Access Compliance Report

Public Rights-of-Way

(Curb Ramps)

Intersection ID: 19602	Main Street: VILLAGE_LAKE_DR	Cross Street: CEDAR_GLEN_DR	Location: W
ADA ID: BC7F947AF8FA	Ramp Type: Directional1	Initial Pass/Fail: Fail	Overall Compliance: No
			Severity Score: 21.25

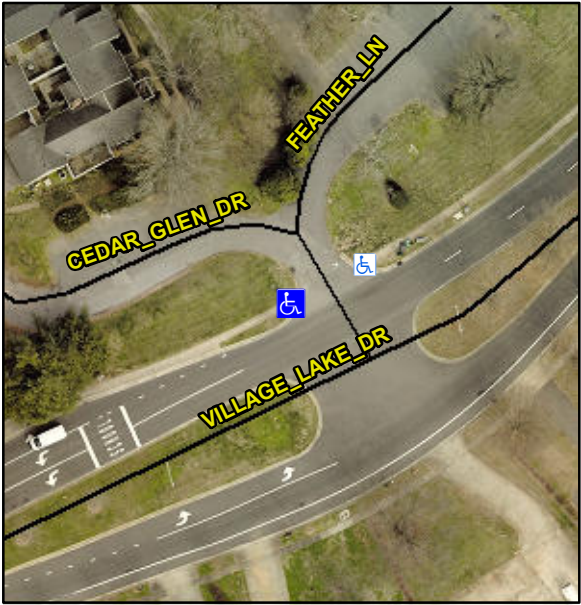
Codes/Mitigation Info/Possible Solution		Field Measurements/Component Compliance			
		Possible Solutions:	Compliance	Description	Data
		Remove & Replace Entire Ramp.	N/A	Ramp Length (in)	122.0
<p>Surveyor Notes:</p> <p>N/A</p>			No	Ramp Width (in)	47.5
			Yes	Ramp Slope (%)	7.1
<p>PROW/ADA:</p> <p>R304.5.1, R304.5.3</p>			No	Ramp XSlope (%)	5.8
			N/A	Flare Type LT	N/A
			N/A	Flare Slope LT (%)	N/A
			N/A	Flare Traversable LT?	N/A
			N/A	Landing Length (in)	0.0
			N/A	Landing Width (in)	0.0
			N/A	Landing Slope (%)	0.0
			N/A	Landing X Slope (%)	0.0
			N/A	Landing Curb? (Y/N)	N/A
			N/A	Shared Landing?	N/A
			N/A	Gutter Ponding?	0.0
			N/A	Gutter Lip Ht (in)	0.0
			N/A	Painted X Walk1?	No
				X Walk 1 Direction	To NE
				X Walk 1 Width (in)	N/A
				X Walk 1 Slope (%)	2.7
				X Walk 1 X Slope (%)	0.3
			N/A	Ramp inside XWalk1?	N/A
			N/A	Any Obstructions?	N/A
				Obstruction Type	
			Yes	Surface Condition? (G/P)	Good

N/A	Curb Slope (%)	24.2
<p>Total Cost: \$ 1600.00</p>
